Vehicle Standard (Australian Design Rule 46/00 – Headlamps) 2006 Amendment 2

2.1. The changes specified in Schedules 1 and 2 amend Vehicle Standard (Australian Design Rule 46/00 – Headlamps) 2006.

Appendix H*

The text reproduced below was prepared by the expert from the Working Party "Brussels 1952" (GTB) in order to introduce into the Regulation provisions for light-emitting diode (LED) modules. The proposal consolidates and supersedes ECE/TRANS/WP.29/GRE/2006/44. The modifications to the current text of the Regulation (up to Supplement 7 to the original version) are marked in bold or strikethrough characters.

"Annex 4 - Appendix 1

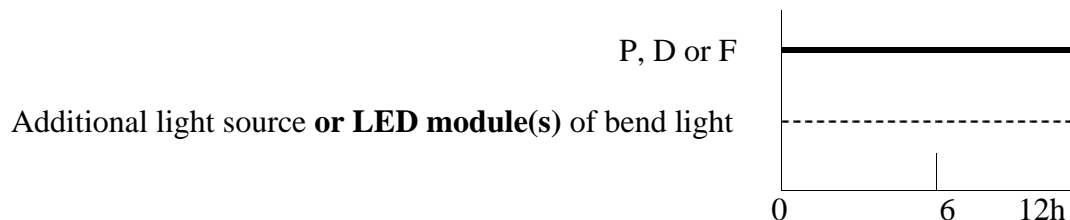
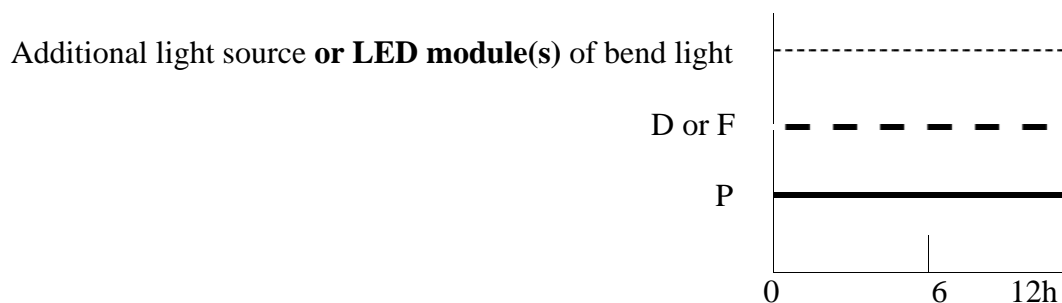
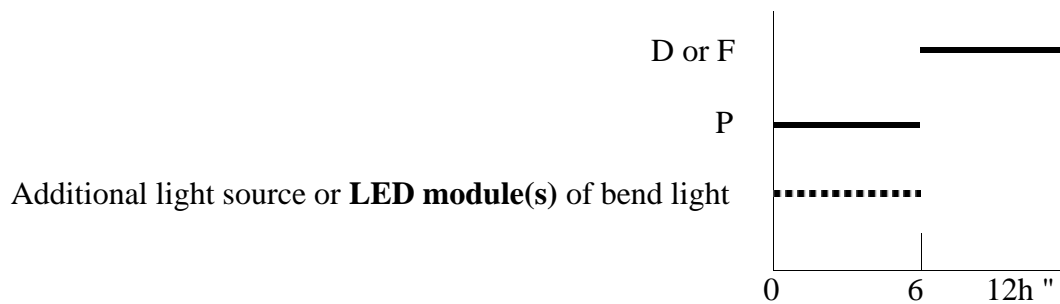
Annex 4 - Appendix 1, amend to read:

OVERVIEW OF OPERATIONAL PERIODS CONCERNING TEST FOR STABILITY OF PHOTOMETRIC PERFORMANCE

Abbreviations:	P:	passing beam lamp
	D:	driving beam lamp (D ₁ + D ₂ means two driving beams)
	F:	front fog lamp
	- - - -	means a cycle of 15 minutes off and 5 minutes lit
	means a cycle of 9 minutes off and 1 minute lit
